Mack MMD Fan Hub Bolt Torque

Revised 7/8/2025 Updated the torque information.

Model Years	Models
2025	MD6, MD7

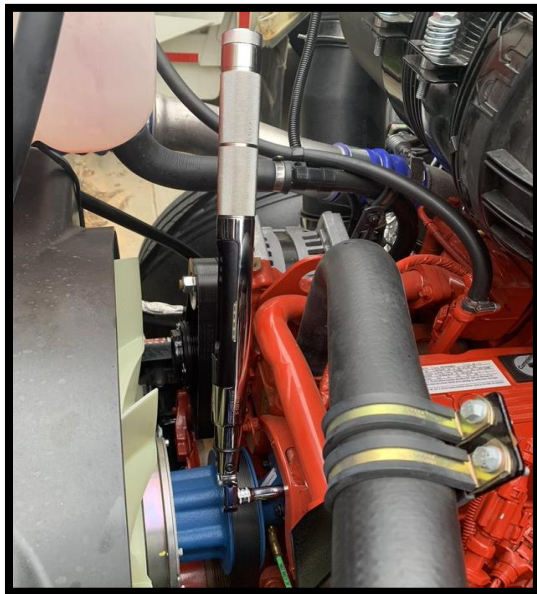
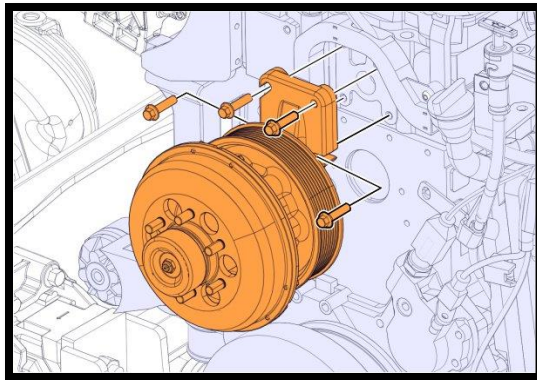
7. Using a torque wrench, retorque the 4-fan hub mounting bolts.

If any fan hub mounting bolts are missing or damaged, replace them with new ones as necessary.

Tightening torque	
Fan hub mounting hardware	24±4Nm (18±3lbf·ft)
